PRODUCT CAMPAIGN BULLETIN

APPLICABILITY: 2009-2012MY Subaru Forester
SUBJECT: Rear Seat Center Seatbelt

NUMBER: WQA-37
DATE: March 2012

REVISED: 10/10/12

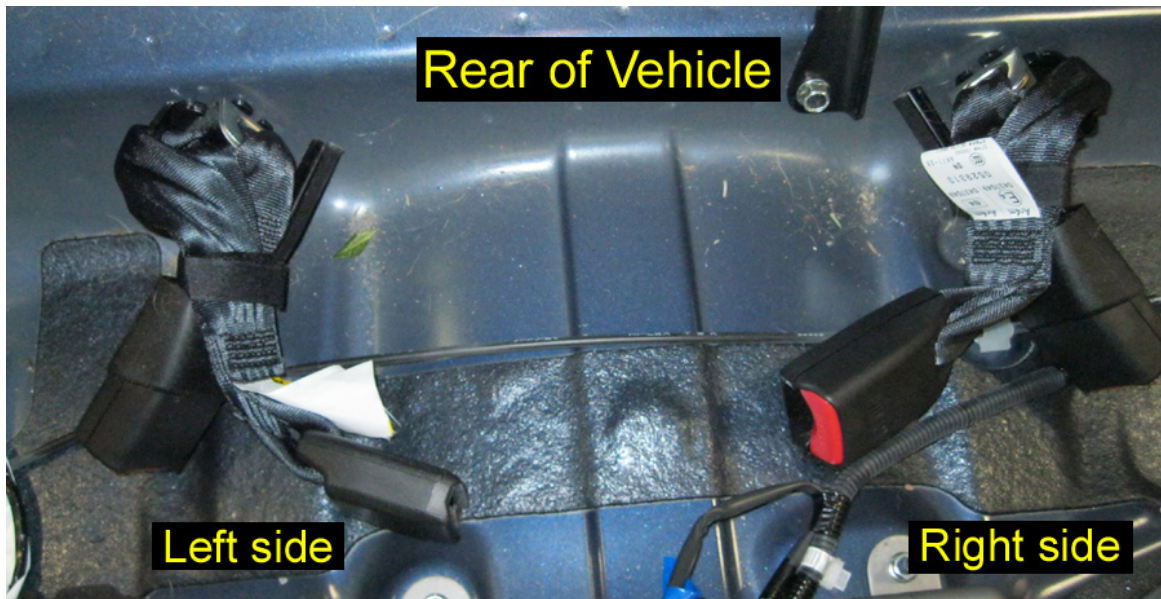
The center seatbelt with “Key Slot Release” requires replacement.
The center seatbelt buckle marked “Center” requires replacement.

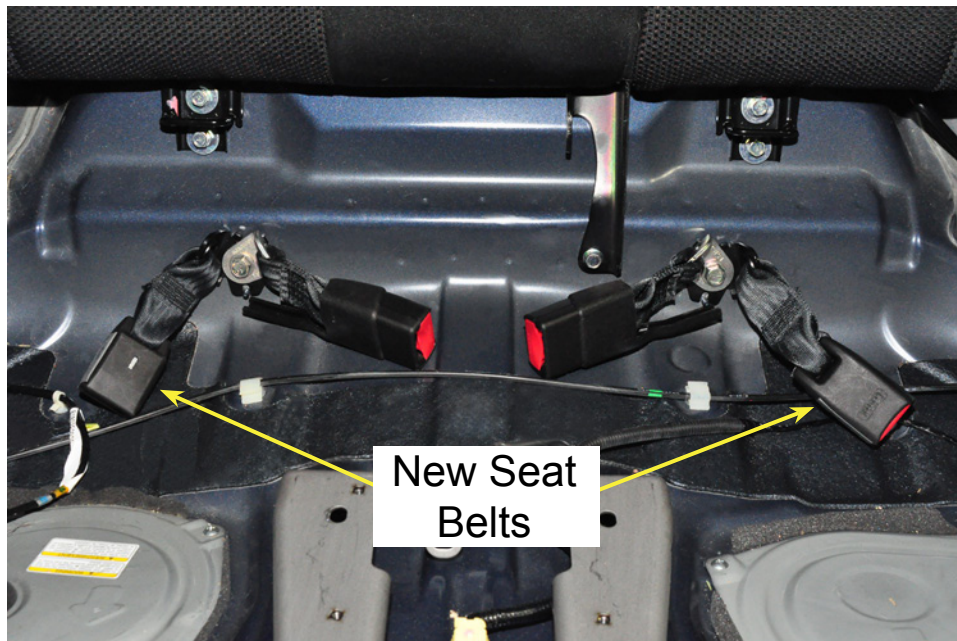
8. Reinstall assemblies into vehicle and torque to spec. 30 N-m (3.06 kgf-m, 22.1 ft-lb)

Note: The replacement belts will be shorter than the original belts. This is intentional. Always use matched belt sets. Do not intermix original and campaign belts

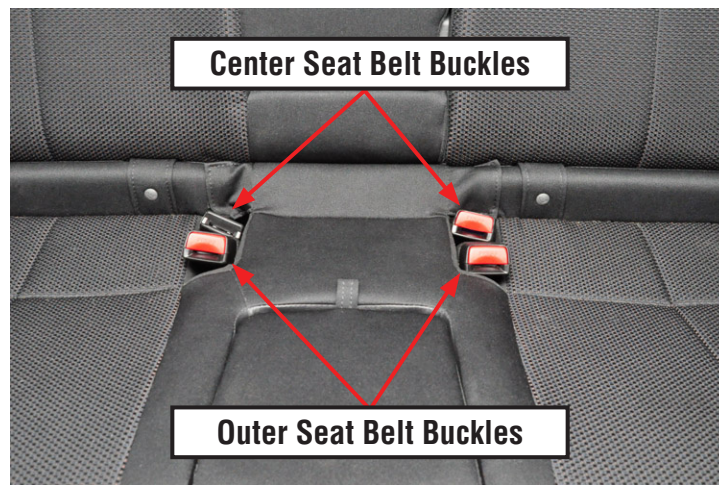
This page should clarify two areas of the Campaign and does not represent any change in procedure. The first clarification is the length of the recall belt. By design, the recall replacement belt is shorter than the original belt.

The second clarification is the final buckle/ latch orientation for the center belt. The red latch release button must face away from the seating position it services. Access to the red latch release button must not be blocked by the belt when it is latched in place for use.

Figure 1: WQA-37 Kit 2

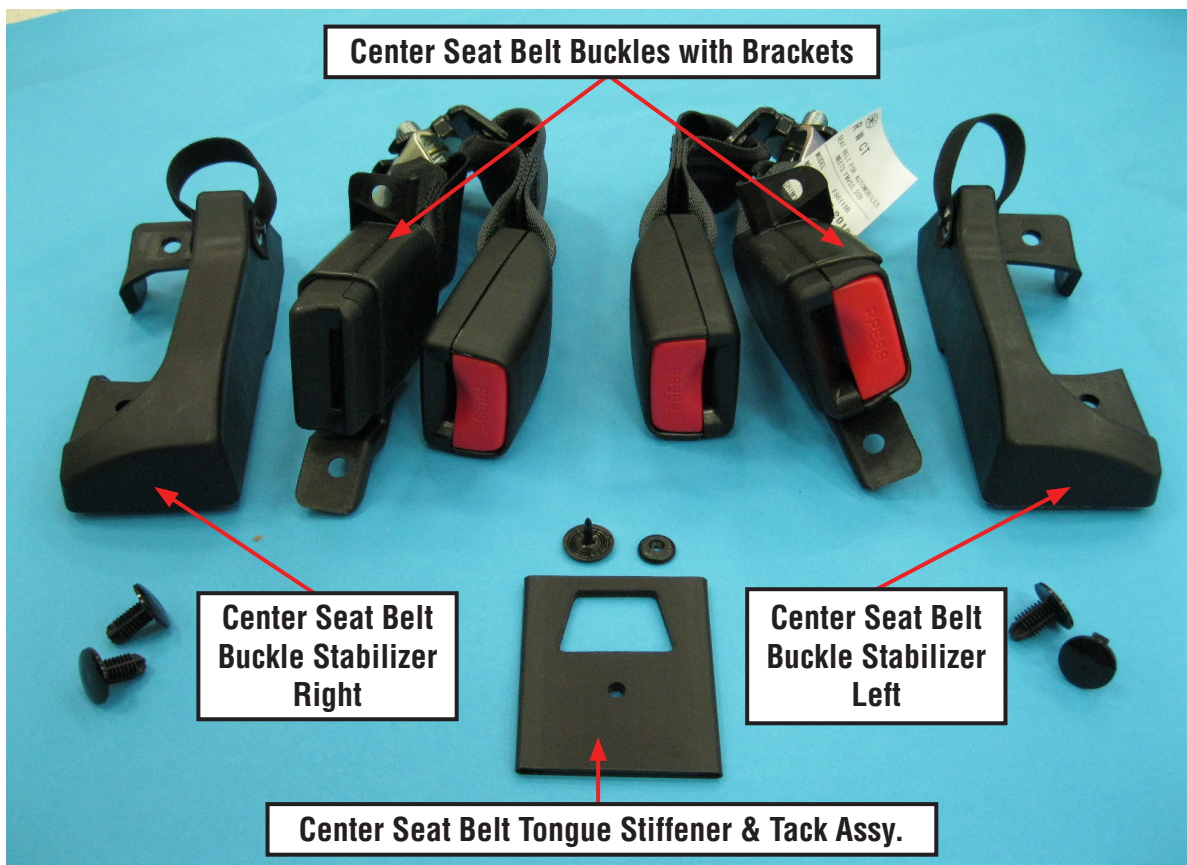
Note: The belts for Kit 2 are shorter than original belts and also shorter than those used for Kit 1. This is intentional.
